Project Name: Westman Mill  
 Concept Design Review

Master File #: 17-2795  
 Date: September 28, 2017

Prepared by Catherine McCoy, Associate Planner

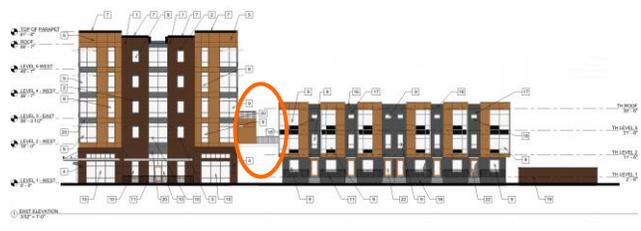
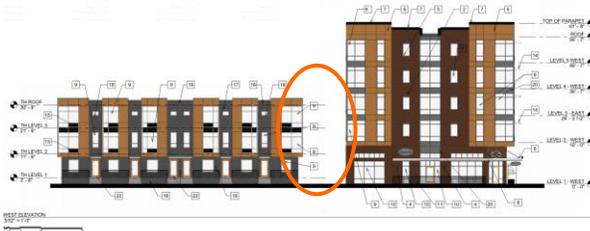
**STAFF RESPONSE:** *The facades of the buildings are well-proportioned in terms of bays, fenestration, materials and patterns. There are a few inconsistencies in the elevations, such as the one below that depicts the second story outdoor common area in the east elevation of the two buildings, but not in the west elevation. Sun shades are not shown consistently around the larger building’s entire envelope – note Renderings R.01-R.04.*

Solar shading should be considered for the townhouse buildings as well, given the buildings face directly east and west.

Reconcile discrepancies of the design of the buildings in the plan set elevations. Provide solar shading around the main building envelope, and on the townhouse buildings.

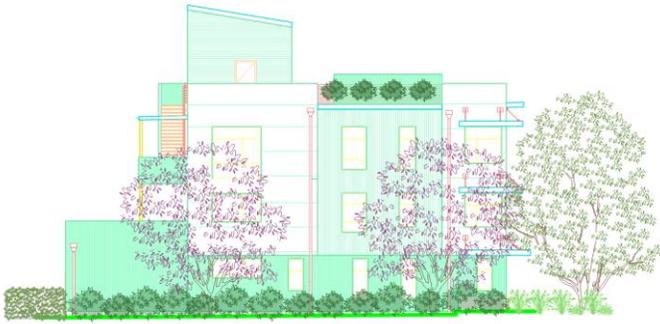
**STAFF RESPONSE:** *Plants should be native or drought tolerant, and should enhance features and activities of on and off-site uses (i.e., along the State Avenue façade). Plantings should also provide privacy for townhouse residents and clearly demarcate the private, semi-private, and public areas along the sidewalk(s).*

Provide black and white or colored elevations that depict street-level landscape design – between the retail spaces along the State Avenue frontage, along the boardwalk, between the sidewalk and the townhouse porches/stoops, in the plaza area in the northeast corner of the building (use a separate sheet if necessary). Note the example provided below. Depict short-term bicycle parking and projections in the right-of-way (e.g., overhead weather protection) in the Landscape Plan.
